**APPLICATION FOR WITHHOLDING PROPRIETARY
INFORMATION FROM PUBLIC DISCLOSURE**

REVISED THERMAL DESIGN PROCEDURE

RESPONSE TO NRC QUESTIONS ON WCAP-11397,
REVISED THERMAL DESIGN PROCEDURE"

Figure 2-1

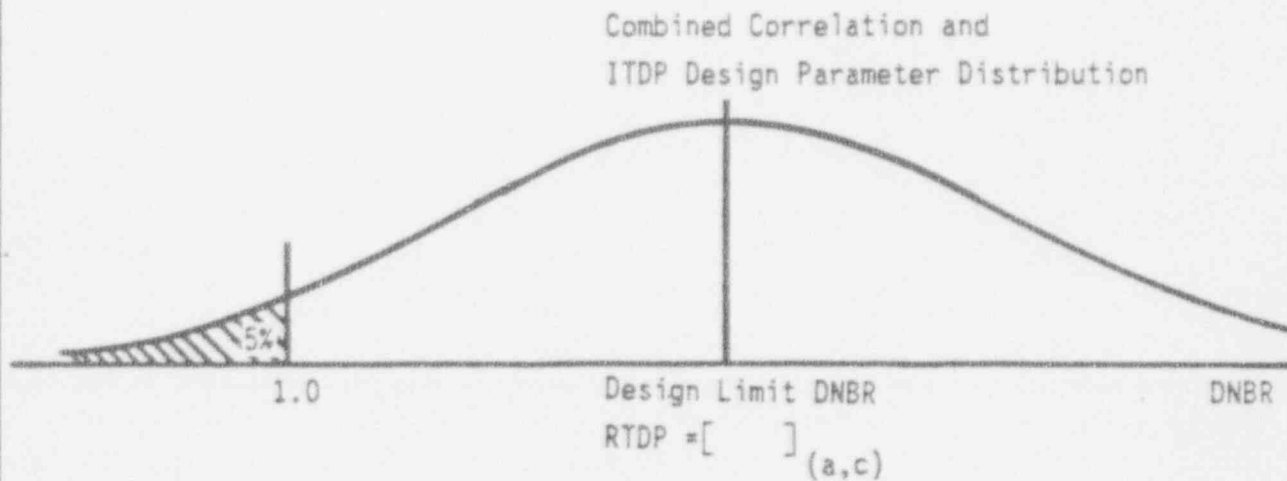
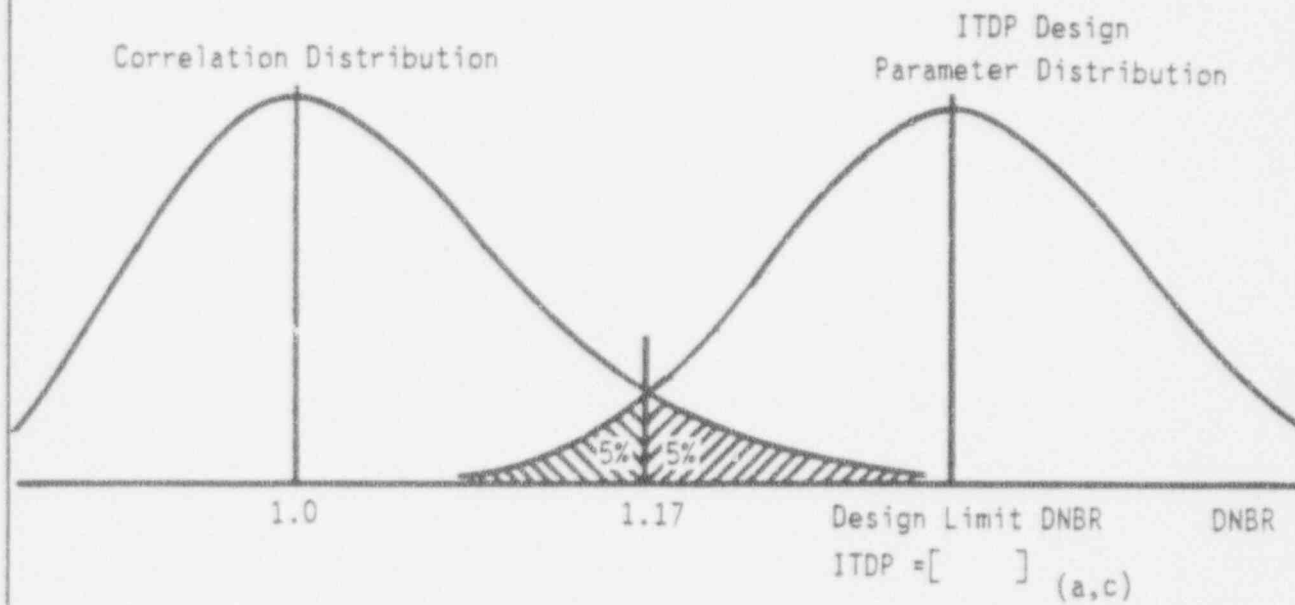
A tolerance interval is a statement about a single distribution. Although the RTDP figure and caption on the bottom of page 8 suggest that the RTDP method is considering a single distribution that combines the correlation and design parameter uncertainties, the development on page 6 seems to indicate otherwise. Specifically, Eq. (2-18) computes a tolerance interval for the "correlation uncertainty" distribution, while Eq. (2-20) is the result of a 95% confidence interval on the combined distribution where a "tolerance interval inflated" variance is used for the correlation uncertainty. This RTDP approach is similar to, but not quite the same as what would be obtained if a 95%/95% tolerance interval was computed on the combined distribution under the assumption that $\sigma(y)$ is known without error.

The approach used in RTDP is the same as that in ITDP with M/P included among the independent variables. The response to question 4 includes the NRC comments on the statistical approach used in ITDP.

Figure 2-1

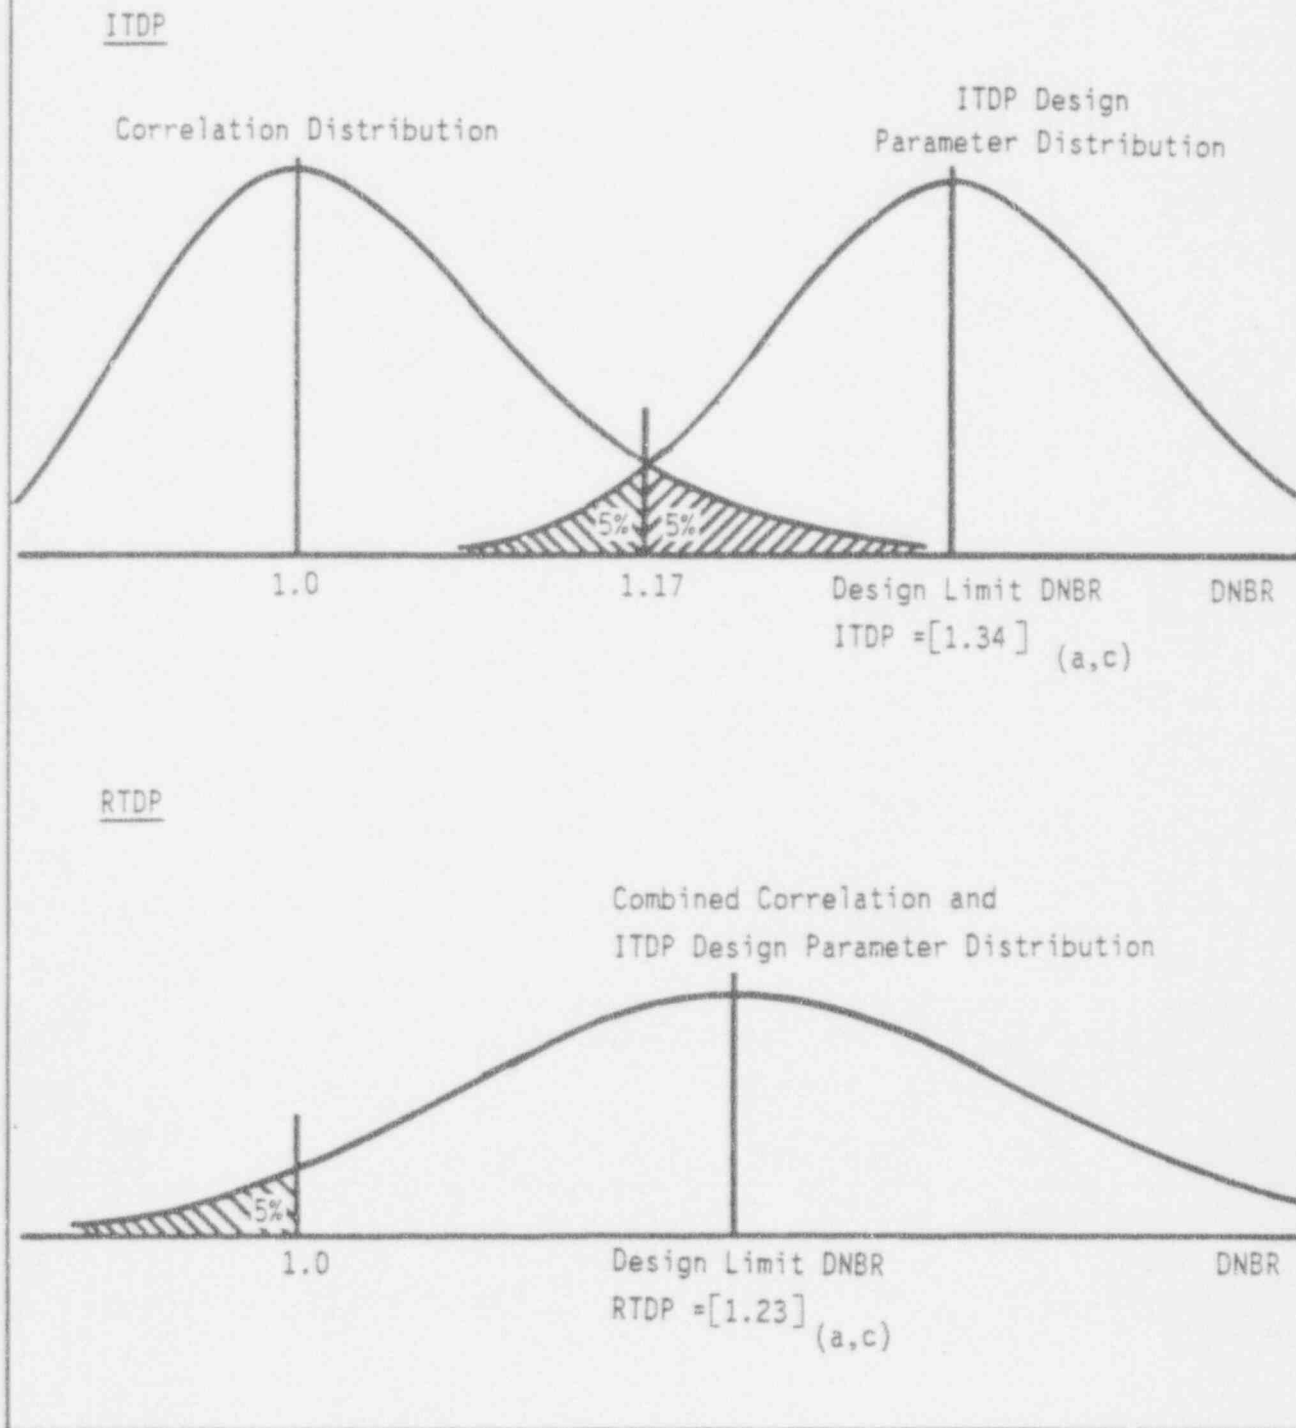
A tolerance interval is a statement about a single distribution. Although the RTDP figure and caption on the bottom of page 8 suggest that the RTDP method is considering a single distribution that combines the correlation and design parameter uncertainties, the development on page 6 seems to indicate otherwise. Specifically, Eq. (2-18) computes a tolerance interval for the "correlation uncertainty" distribution, while Eq. (2-20) is the result of a 95% confidence interval on the combined distribution where a "tolerance interval inflated" variance is used for the correlation uncertainty. This RTDP approach is similar to, but not quite the same as what would be obtained if a 95%/95% tolerance interval was computed on the combined distribution under the assumption that $\text{sign}(y)$ is known without error.

The approach used in RTDP is the same as that in ITDP with M/P included among the independent variables. The response to question 4 includes the NRC comments on the statistical approach used in ITDP.
